Field Inspection Program

LETTER OF VIOLATION - Inspection

| ANTELOPE No.001 | | | | A-7-15S-35E | 30-025-38867-00-00 | |

GEARBOX LEAK STARTING
TO REACH THE POND

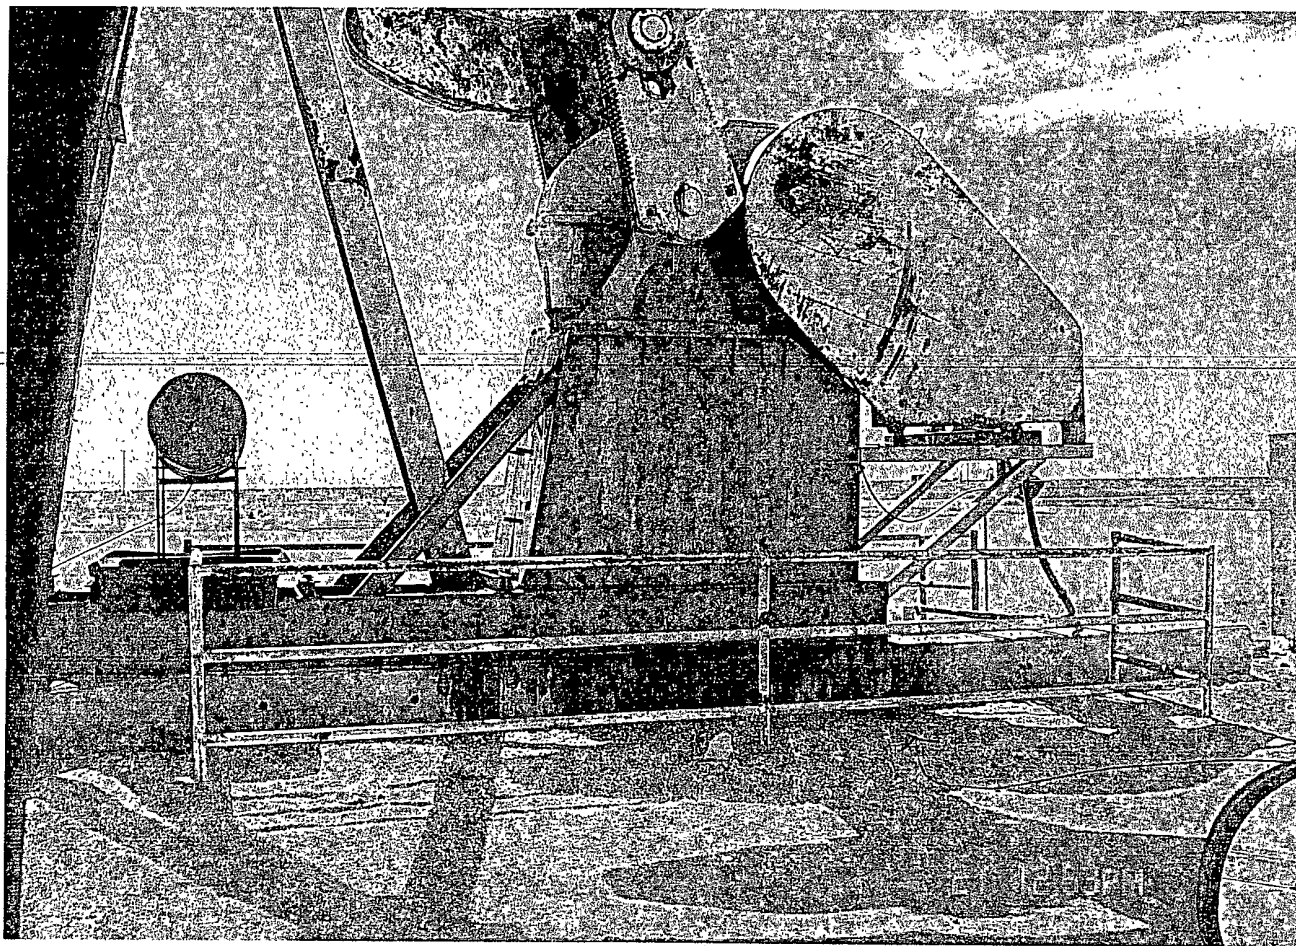
| ANTELOPE No.001 | | | | A-7-15S-35E | 30-025-38867-00-00 | |
|-------------------------|---|-------------|------------|------------------------------|---------------------------|----------------|
| Comments on Inspection: | FOLLOWUP ON COMPLAINT FROM LAND OWNER. NEED TO REMOVE CONTAMINATED SOIL(SLUDGE) AND OILY RAGS LOCATED BY NW ANCHOR. CIRCULATING PUMP HAS LEAKED AND CONTAMINATED SOIL AROUND PUMP NEED TO REMOVE SOIL AROUND PUMP AND PILE OF OILY SOIL NE OF PUMP ALSO GEARBOX ON PUMPING UNIT IS LEAKING AND GEAR OIL IS RUNNING ONTO THE GROUND. NEED TO CORRECT RULES VIOLATED 19.15.10.8, 19.15.29.8. THIS IS 1ST LETTER OF NON-COMPLIANCE | | | | | |
